# Model DMM7510 7½ Digit Graphical Multimeter

## Version 1.6.1a Firmware Release Notes

## Version v1.6.1a Release

PR54974, UI graph occasionally appears to be missing digitizer data  
 PR54934

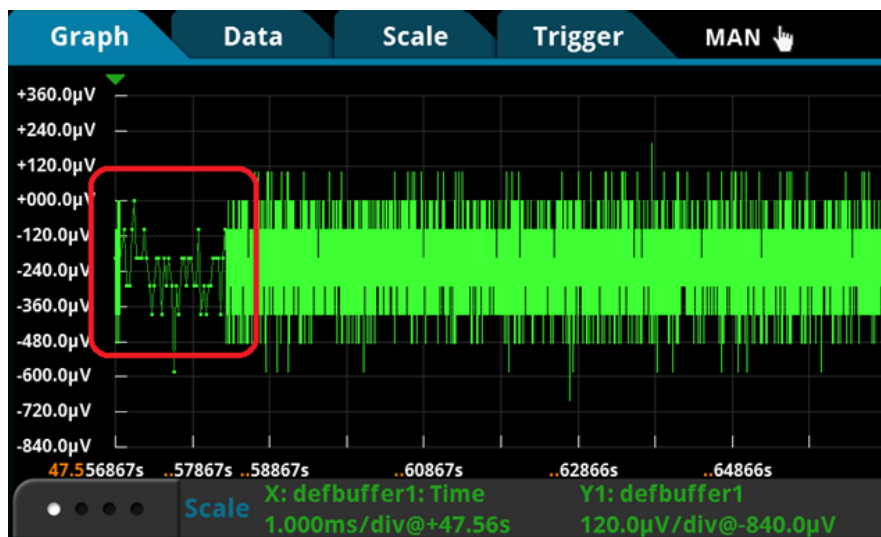
When using the UI to view bursts of digitizer data on the graph, you may see areas that appear to have missing data. Even though data is being sampled consistently throughout the viewable range, it appears as though fewer points are available in the circled area.

This may only occur when more than 5,000 points are visible on the graph at once and sample rates exceed 50k.

This issue has been corrected. Not every measurement point is sent to the display when zoomed out and acquiring high speed digitizer readings in real time. An effort is made to send enough so that the signal can be rendered closely. Pan or scale the graph by touching it to force a refresh if more detail is needed. All data will appear if any improved precision is possible.
